# Access Compliance Report

## Public Rights-of-Way

### (Curb Ramps)

Intersection ID: 17901	Main Street: COLWICK_RD	Cross Street: N_SHARON_AMITY_RD	Location: NW
ADA ID: 38A00E202EBE	Ramp Type: PerpDiag	Initial Pass/Fail: Fail	Overall Compliance: No
Severity Score: 8.75			
Codes/Mitigation Info/Possible Solution		Field Measurements/Component Compliance

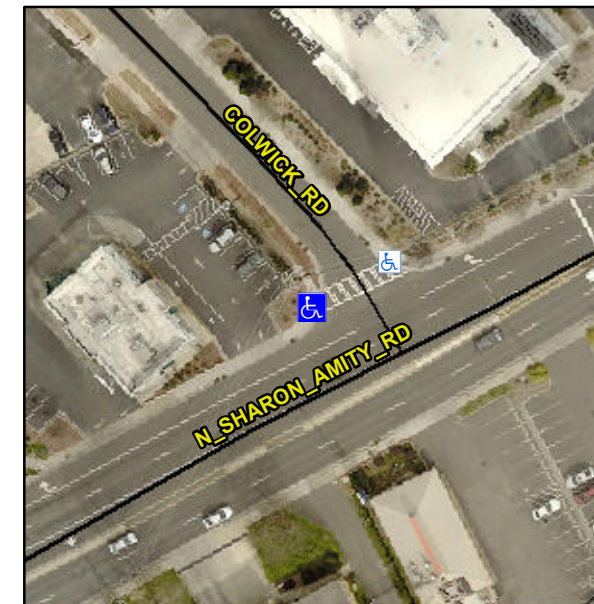
**Not Found, R304.5.1**

Compliance	Description	Data	Compliance	Description	Data
N/A	Ramp Length (in)	71.0	Yes	Ramp Slope (%)	5.9
No	Ramp Width (in)	46.0	Yes	Ramp XSlope (%)	0.7
N/A	Flare Type LT	N/A	N/A	Flare Type RT	N/A
N/A	Flare Slope LT (%)	N/A	N/A	Flare Slope RT (%)	N/A
N/A	Flare Traversable LT?	N/A	N/A	Flare Traversable RT?	N/A
N/A	Landing Length (in)	N/A	N/A	DWS Provided?	N/A
N/A	Landing Width (in)	N/A	N/A	DWS Contrast?	N/A
N/A	Landing Slope (%)	N/A	N/A	DWS Length (in)	N/A
N/A	Landing X Slope (%)	N/A	N/A	DWS Full Width?	N/A
N/A	Landing Curb? (Y/N)	N/A	N/A	DWS Offset (in)	N/A
N/A	Shared Landing?	N/A			
N/A	Gutter Ponding?	N/A	N/A	Gutter Slope (%)	N/A
N/A	Gutter Lip Ht (in)	N/A	N/A	Gutter X Slope (%)	N/A
N/A	Painted X Walk1?	No	N/A	Painted X Walk2?	Yes
	X Walk 1 Direction	To SE		X Walk 2 Direction	To NE
N/A	X Walk 1 Width (in)	N/A	N/A	X Walk 2 Width (in)	112.0
	X Walk 1 Slope (%)	0.1		X Walk 2 Slope (%)	1.5
	X Walk 1 X Slope (%)	1.8		X Walk 2 X Slope (%)	1.3

N/A	Ramp inside XWalk1?	N/A	N/A	Ramp inside XWalk2?	Yes
	Road Slope (%)	1.9	N/A	Clear Space?	N/A
	Road X Slope (%)	0.4	N/A	Clear Space to XWalk (in)	N/A
N/A	Any Obstructions?	N/A	N/A	Storm Grate/Utility Hazard?	N/A
	Obstruction Type			Storm Grate/Utility Type	
		N/A			N/A
			Yes	Surface Condition? (G/P)	Good

**Remove & Replace Curb Ramp With Two New Directional Ramps or Equivalent.**
